SIZE	CODE	IDENT NO.	REV
D	05UV8	B64-13021	C
BLEED AIR ECU DUCT ROUTING			SHEET 4 OF 11

<input checked="" type="checkbox"/> ECO <input type="checkbox"/> ECR	NO. 4425	EFF DATE OF CHG 19 JAN. 95	REQUESTED BY Q.C.	PREMIER	PAGE 1 OF 1
REASON FOR CHANGE ACFT UPDATE		DOCUMENTS AFFECTED SEE BELOW	SYSTEM	MATL DISPOSITION	
MARKED PRINTS ATTACHED YES <input type="checkbox"/> NO <input checked="" type="checkbox"/>		SERIAL NO EFF	REWORK	STORE	IN MFG.
			SCRAP		
			USE AS IS

ENGINEERING CHANGE ORDER PREMIER AVIATION, INC 2621 AVIATION PARKWAY, GRAND PRAIRIE, TX 75052 FSCM - OSUV8				REQUESTED BY ENGINEERING		DATE OF CHANGE 4/6/98		ECO NO. 5471 <small>ECO 5171</small>		SHEET OF 1 11	
FAA SUBMITTAL YES <input checked="" type="checkbox"/> X NO <input type="checkbox"/>				STC(s) AFFECTED: SH8443SW				APPROVALS			
				PREPARED BY C.R.SHORT				DATE 03/19/98			
REASON FOR CHANGE				DOCUMENT AFFECTED							
FACILITATE FAB.				DESIGN ERROR				CHECKED		DATE	
CUSTOMER CHANGE				DRAFTING ERROR				<i>J. Harbinger</i>		4/6/98	
DESIGN CHANGE		<input checked="" type="checkbox"/> X		ADDITION DESIGN INFO				QUALITY		DATE	
OTHER				B64-13021		C C		10/19/94		4/6/98	
				TITLE BLEED AIR ECU DUCT ROUTING				<i>C. R

-99 FLAP

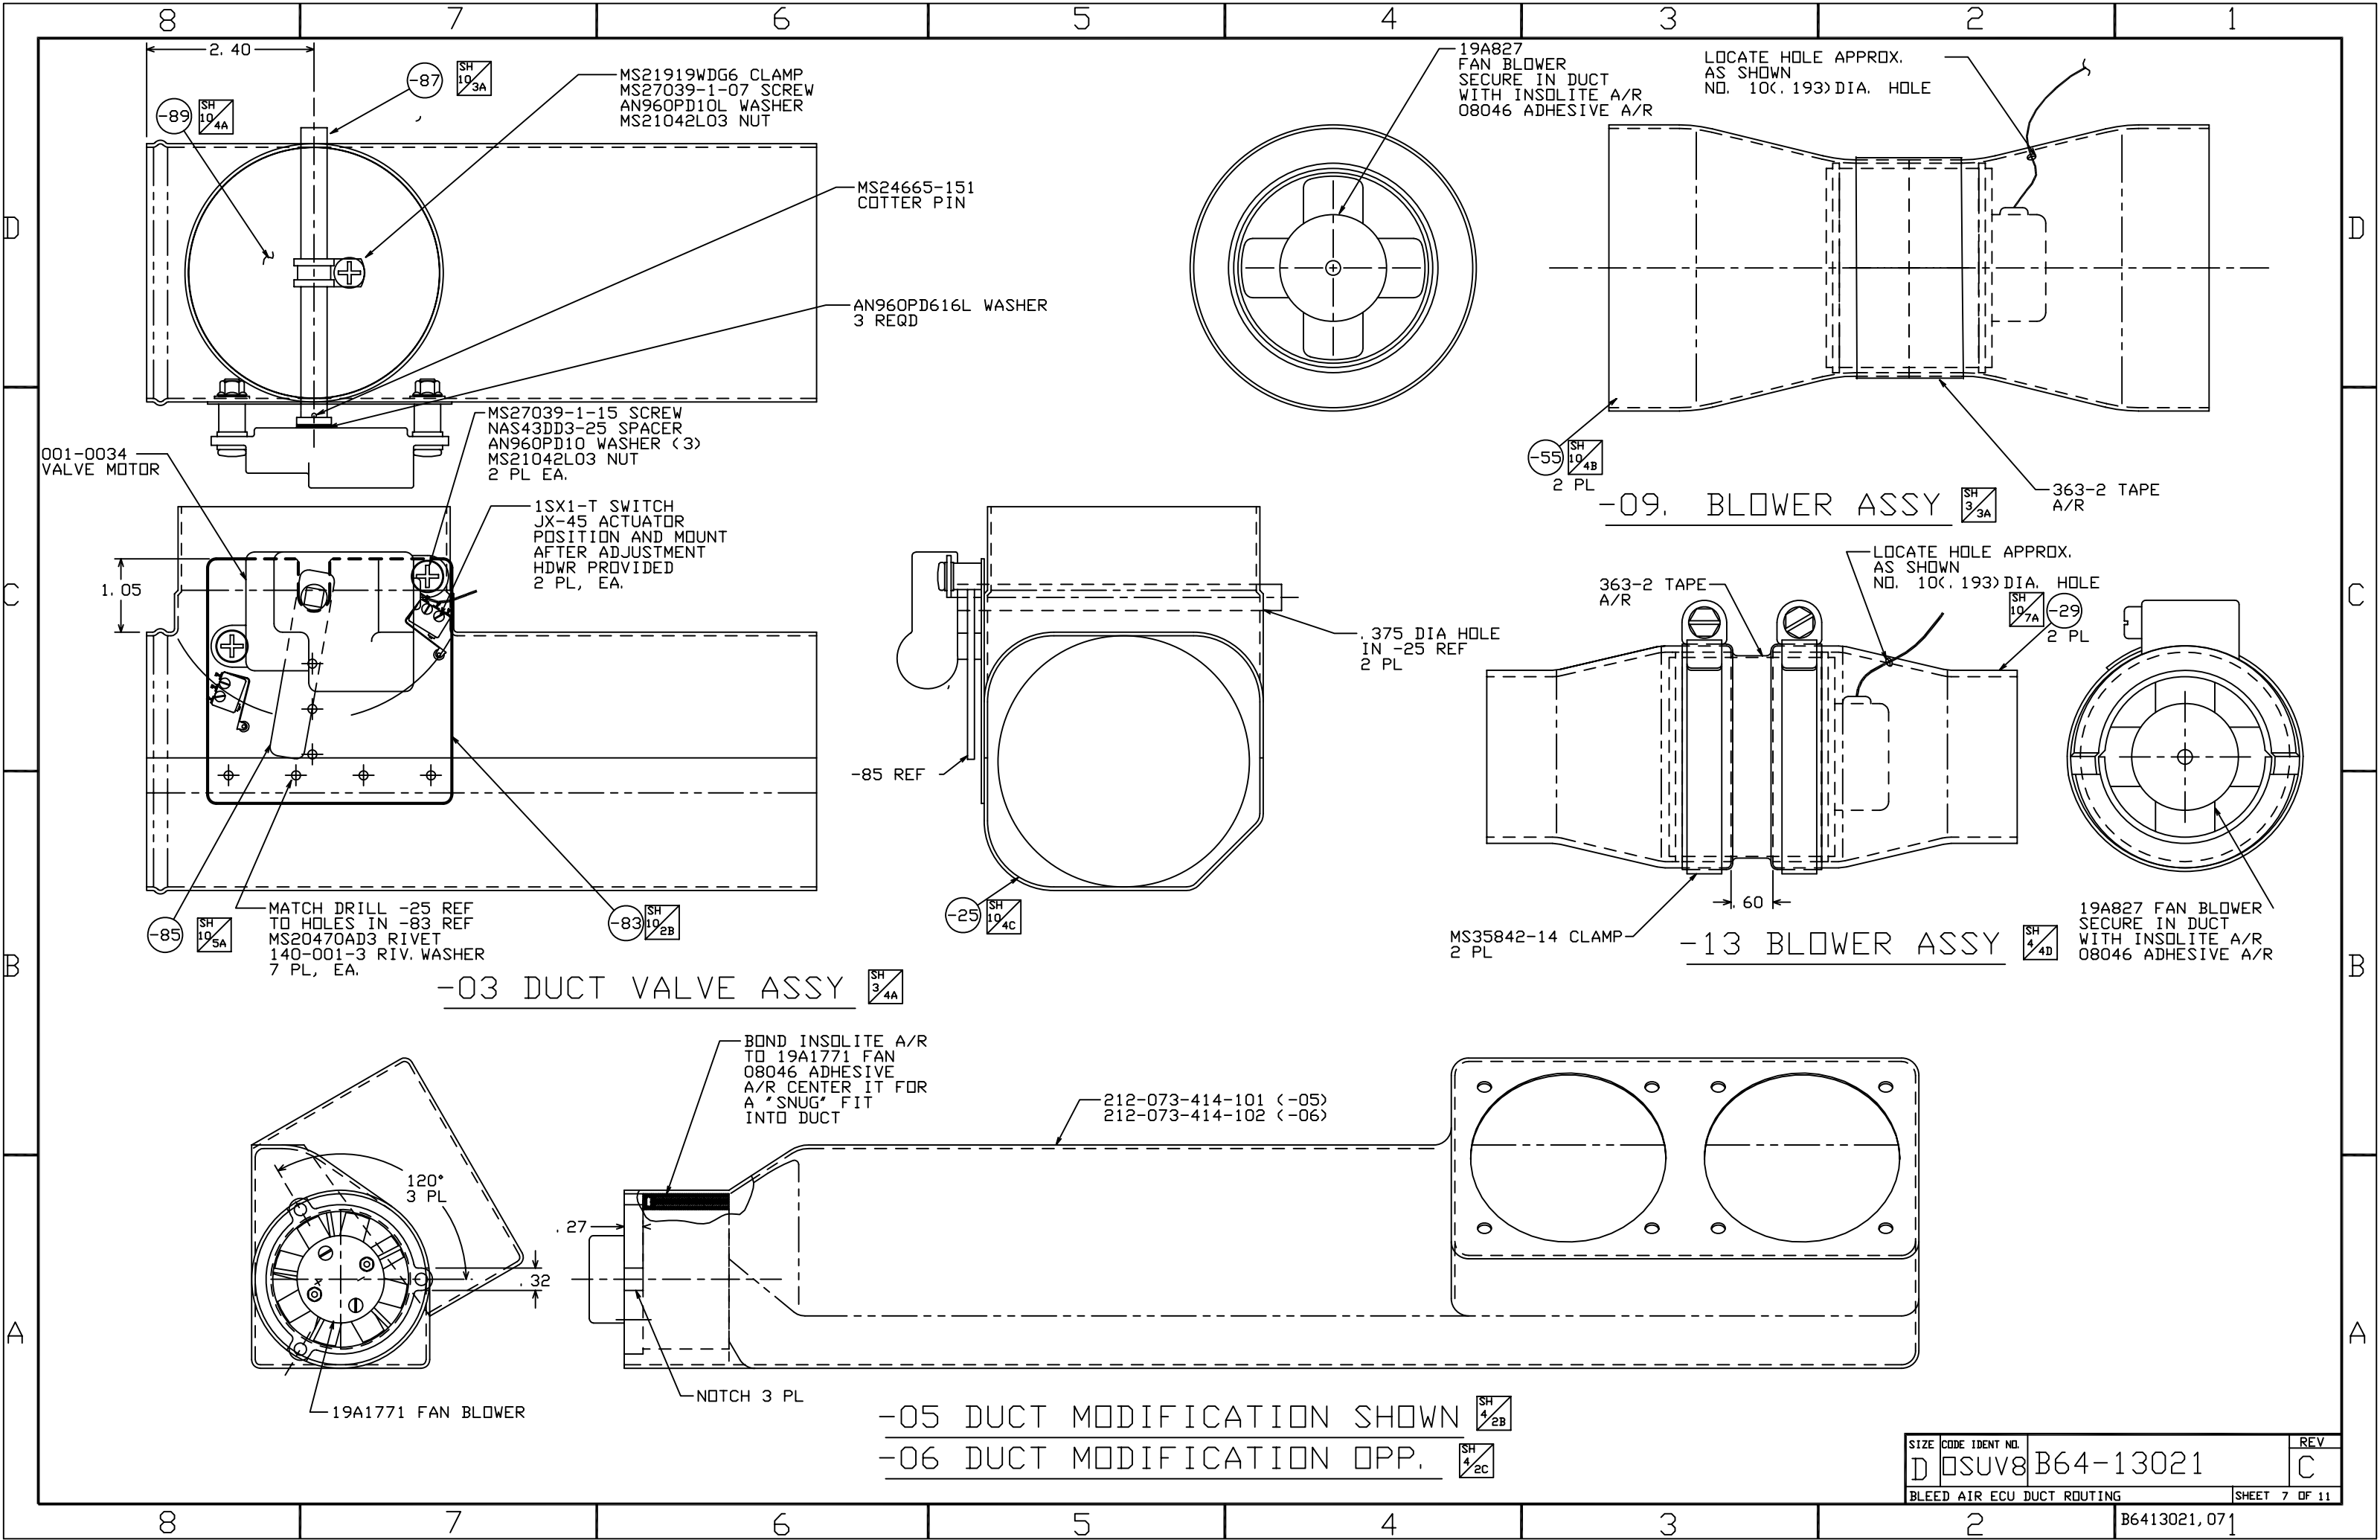
LOCATION : DUGW. NO. B64-13021, SHEET 6, ZONE 5B.

(WAS) .190 THK KYDEX 100

(WAS:) - 99 LAP

M/F. 19 THK KYDEX 100

ALTERNATE MATERIAL:
(IS) .125 THK KYDEX 100

(IS:) - 99 LAP

M/F. 19 THK KYDEX 100

ALT: .125 THK KYDEX 100

-87 SPACER

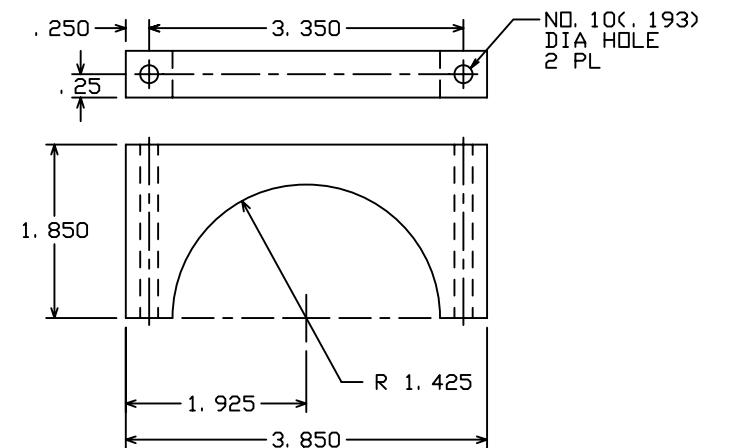
LOCATION: DWG. B64-13021, SH. 10, ZN. 3A

(WAS:) **- 87 SPACER**
M/F: NAS43DD4-160 SPACER

(IS:) **- 87 SPACER**
M/F: NAS43DD4-320 SPACER
ALT. MATL: 2024-T3 TUBE PER
QQ-A-200/3, .375 OD X .045 MIN WALL

DESCRIPTION: SHEET 1 ZONE 7A

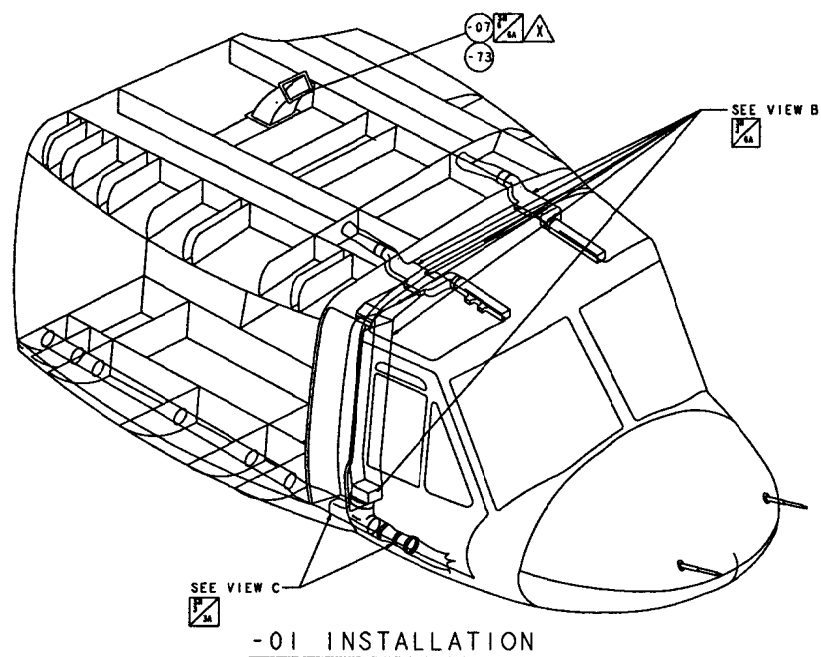
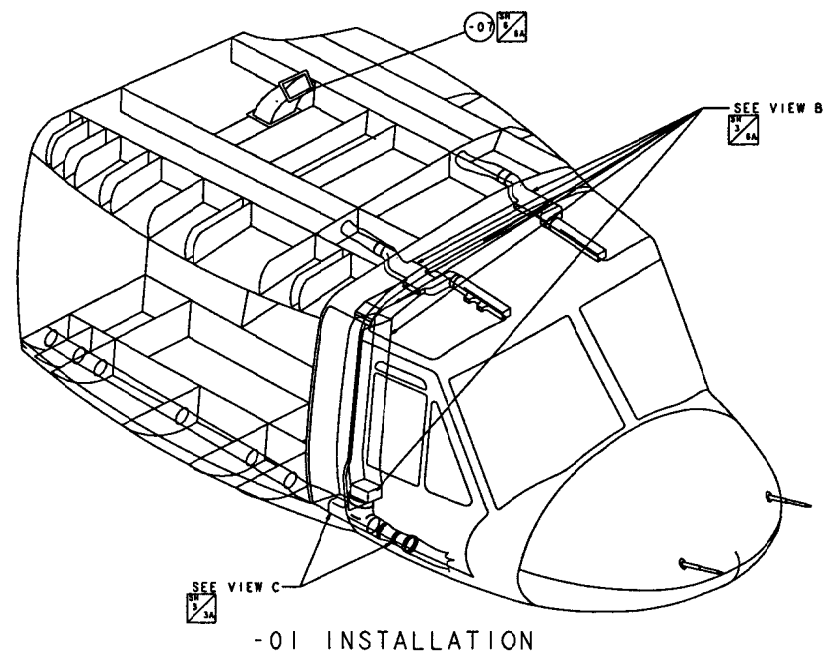
"WAS"

"IS"

SHEET 3 ZONE 3A
 "IS"

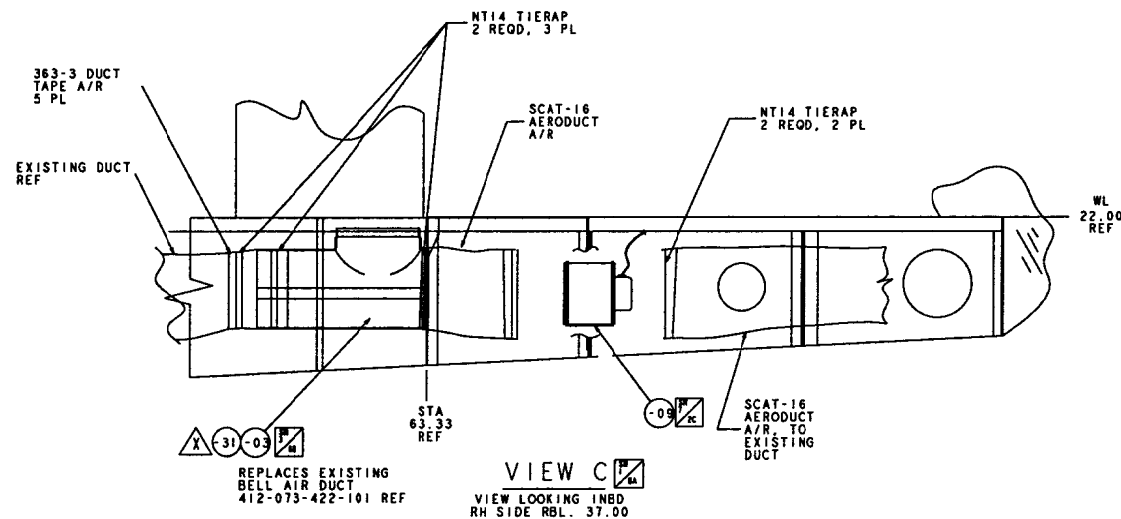
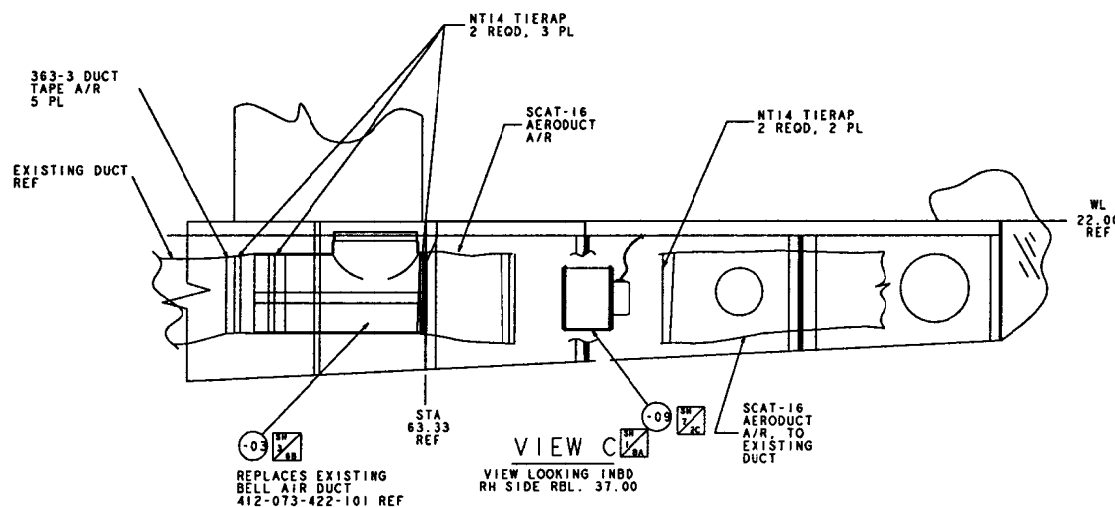
"WAS"

-73 DUCT MODIFICATION A

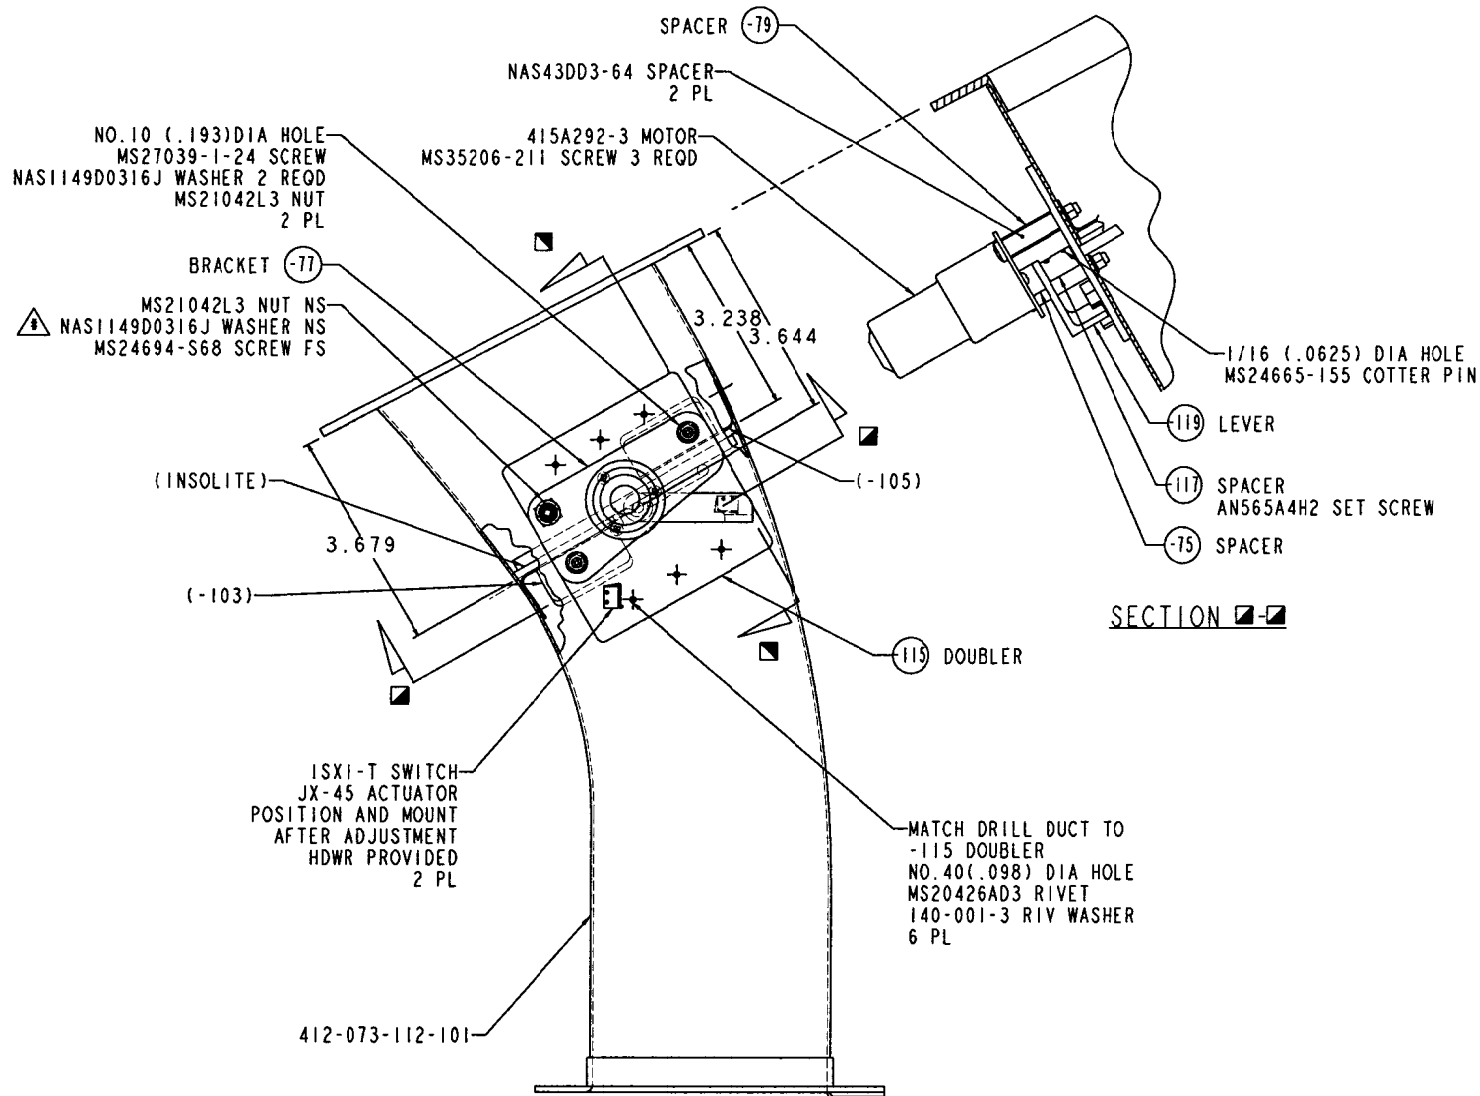
DESCRIPTION: ADD -73
